Re: Turkey Point Units 3 and 4

Response to NRC Reactor Systems Branch Request for Additional Information  
Regarding Extended Power Uprate License Amendment Request No. 205  
and Thermal Conductivity Degradation

RESPONSE TO NRC SRXB RAI REGARDING EPU LAR NO. 205  
AND THERMAL CONDUCTIVITY DEGRADATION

**Figure 5 (Figure 5-19 in Reference 4)**  
**Limiting PCT Case Peak Cladding Temperature for all 5 Rods**

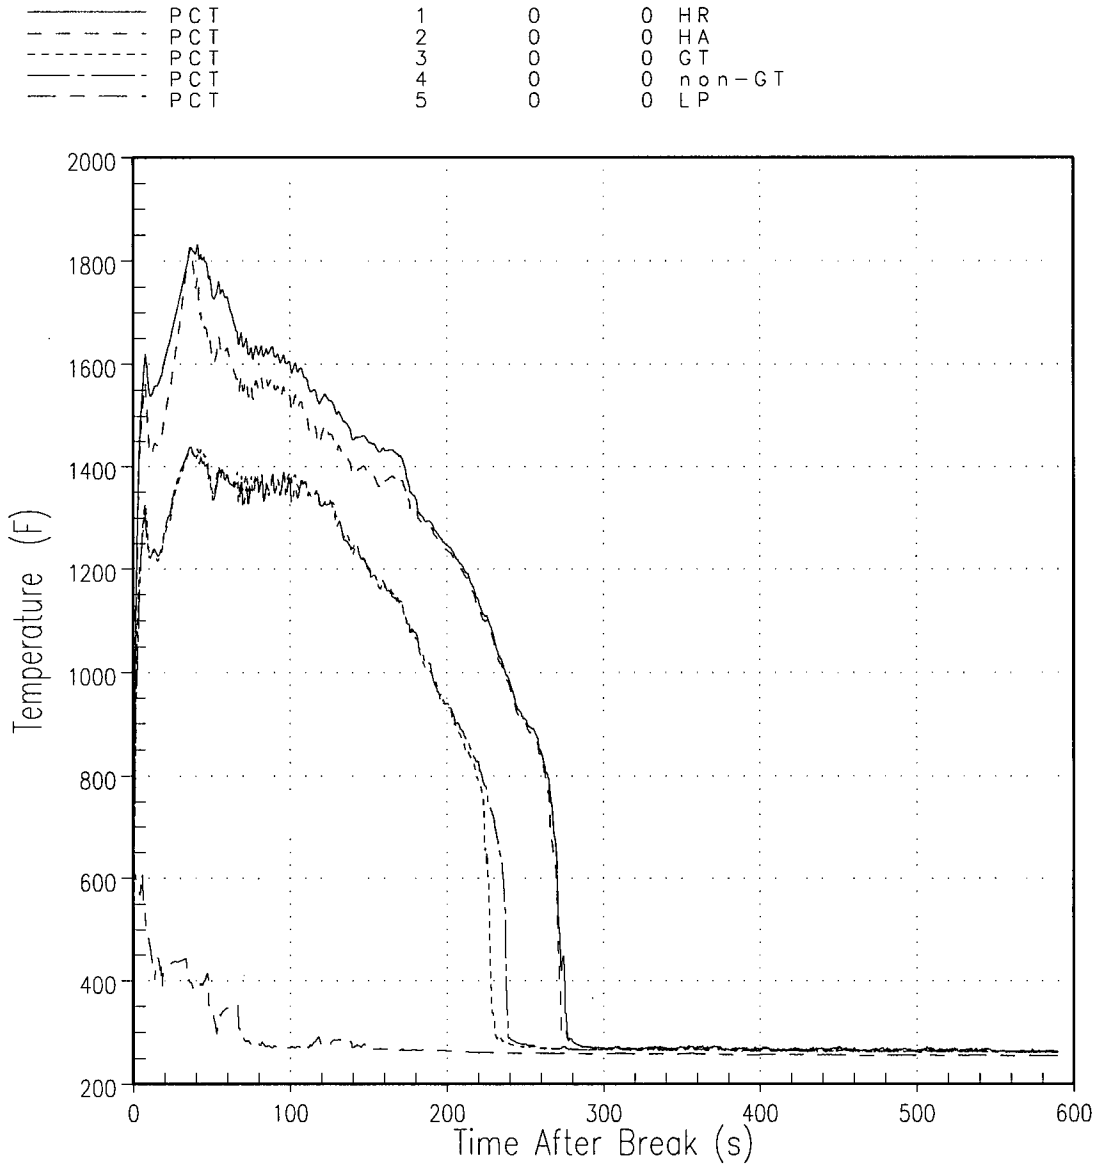
The run time of the limiting PCT and MLO case presented in Reference 4 has been extended to 600 seconds to show a steadily increasing trend in the vessel liquid inventory.

Figure 5 provides the PCT for the five (5) rods modeled in WCOBRA/TRAC. It is observed that the PCT remains quenched for a remainder of the extended simulation.
